Re: Case 16-F-0062 - Application of Eight Point Wind, LLC for a Certificate of Environmental Compatibility and Public Need Pursuant to Article 10 to Construct a 103.4 MW Wind Energy Project

ENCLOSURE 1

Comment Number	Agency	Agency Comment Number	Topic	PSS Document Reference	Agency Comment	Response
1	DAM	Section 3.03-1	Location of Facilities	Section 3.03	PSL Article 10 Application must include a preferred project description which includes all permanent and temporary ground disturbance activities. This should include (but is not limited to): turbine sites, crane pads, electric collection lines, temporary and permanent access roads, permanent met towers, laydown areas, O&M building, and a collection substation.	Comment noted. The Article 10 Application will include the information listed.
2	DAM	Section 3.03-2	Location of Facilities	Section 3.03	The Department is primarily concerned with temporary and permanent impacts to agricultural resources from the proposed Project. Active agricultural land likely includes parcels which may not be located in a County-adopted, State-certified Agricultural District. Agricultural land uses should be identified and designated accordingly regardless

Figure 2: Project Area and Study Area

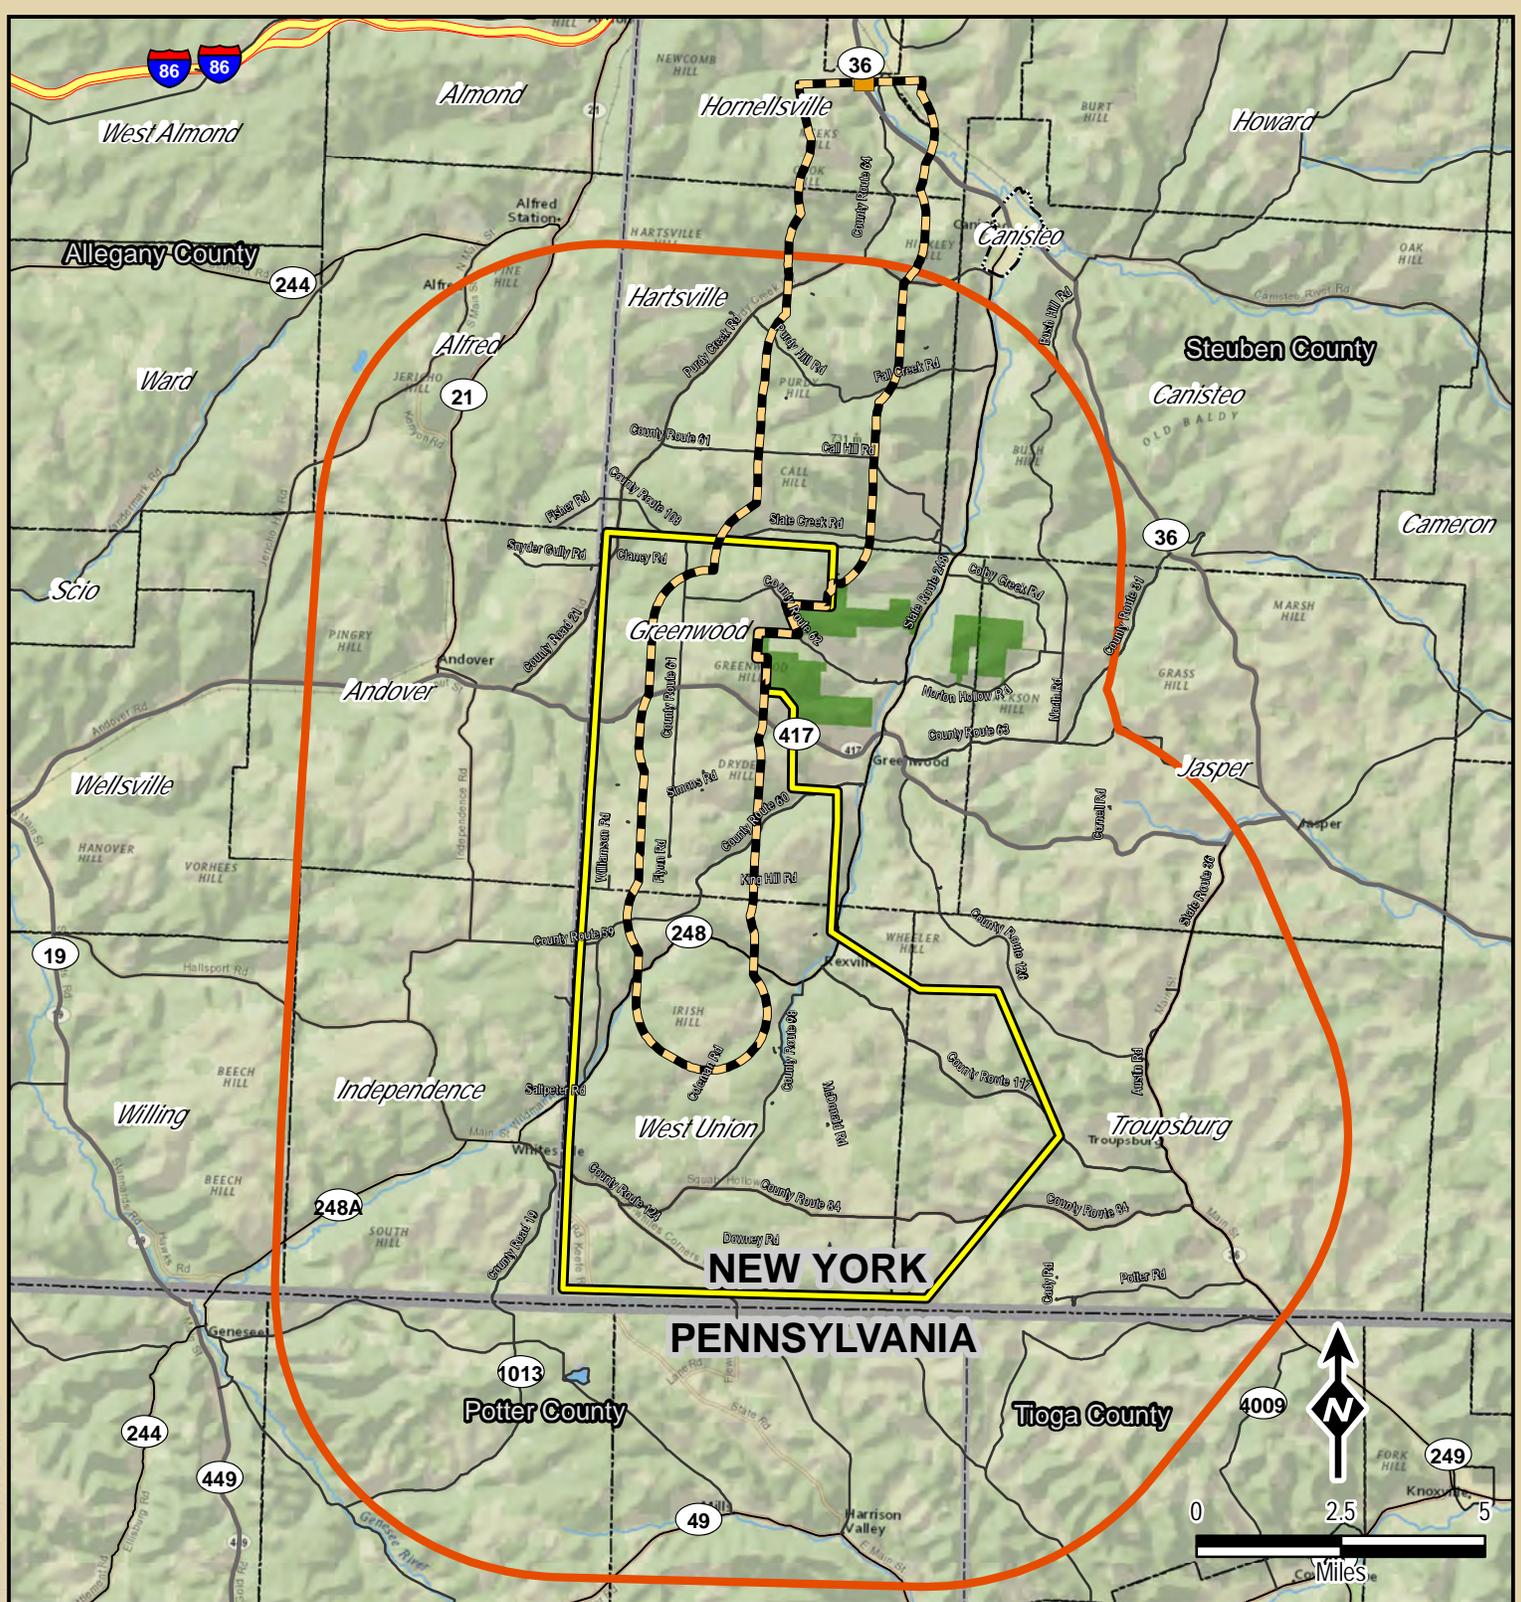
139	DPS	Figures and Appendices, Figure 2-1	Map scale	Figures and Appendices	The scale of Figure 2 is too small to include the location of the City of Hornell, the immediately adjacent municipality to the proposed Point of Interconnection Station in Hornellsville.	Comment noted.
140	DPS	Figures and Appendices, Figure 2-2	Map roads	Figures and Appendices	No roads are identified in the Project Area.	Comment noted. See revised Figure 2.
141	DPS	Figures and Appendices, Figure 2-3	Study Area	Figures and Appendices	The identified 5-Mile Study Area is not applicable to all exhibits in the PSS per the descriptions in the PSS.	Comment noted.
142	DPS	Figures and Appendices, Figure 3-1	Map	Figures and Appendices	The Land Use classifications identified in the Figure 3 Legend do not correspond with the mapped land uses: there is no Forest Land indicated in the Project Area.	Comment noted. See revised Figure 3.

Figure 5: New York Agricultural Districts in the Project Area

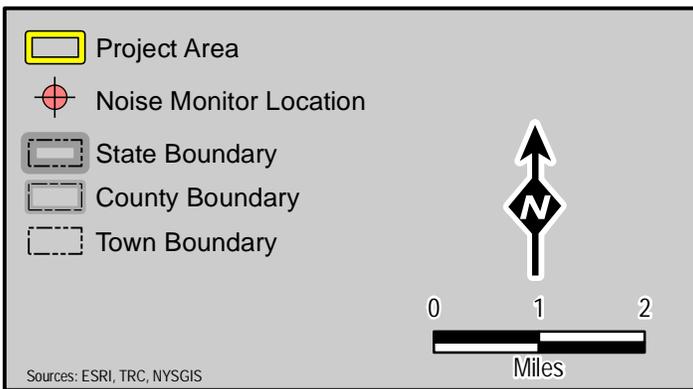
143	DPS	Figures and Appendices, Figure 5-1	Map	Figures and Appendices	The depiction of enrolled properties in Figure 5 does not correspond with the Steuben County Agricultural Districts map published at the NYSDAM website.	Comment noted. See revised Figure 5.
144	DPS	Figures and Appendices, Figure 7-1	Map	Figures and Appendices	The location of Noise Monitoring Locations cannot be ascertained from the information in Figure 7: the scale of the map is too small and there are no corresponding roads or other relational landmarks for reference.	Comment noted. See revised Figure 7.
